#### About this application note

This application note seeks to correct a problem that may occur when using the **In Situ Programming (ISP)** feature on **ST7MDT1-DVP2** and **ST7MDT2-DVP2** development kits.

## Workaround to ISP Mode Limitation on the ST7MDT1-DVP2 and ST7MDT2-DVP2

Figure 3: Location of ISP driver chip on the ST7MDT2-DVP2

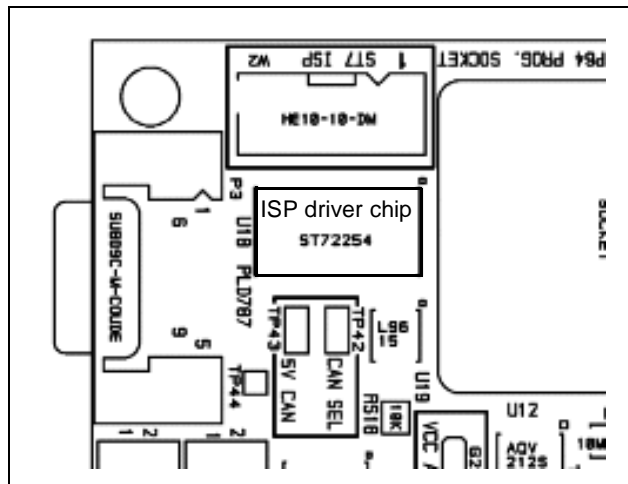
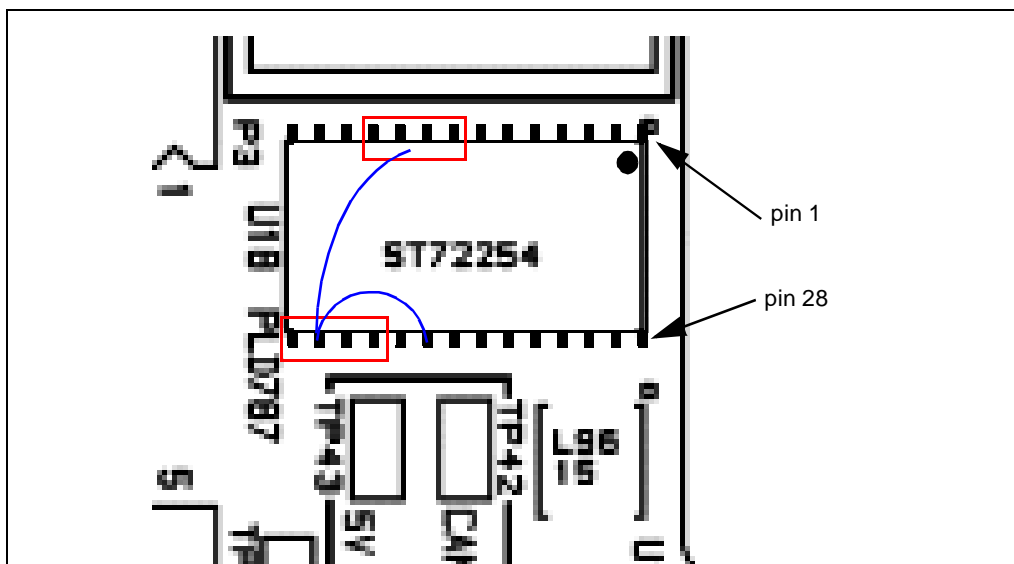
- 1 Locate the ISP driver chip (ST72254), in the corner of the DVP board, close to the ISP connector. *Figure 3* shows the location of the driver chip (labelled U18) for the ST7MDT2-DVP2. The driver chip is in a similar location (labelled U17) on the ST7MDT1-DVP2.

- 2 Once you have located the ST72254 ISP driver chip, find pin 1 of the chip which is indicated by an indentation in the top of the chip's package.
- 3 Solder the following pins together:
  - Pins 8, 9, 10, 11
  - Pins 15, 16, 17, 18

- 4 Solder one end of an insulated wire from Pins 8, 9, 10 and 11 (which are already soldered together). Solder the other end of the same insulated wire to Pins 15, 16, 17 and 18 (also soldered together).

- 5 Take a second insulated wire, and solder the first end to Pins 15, 16, 17 and 18 (soldered together) and the other end to pin 20.
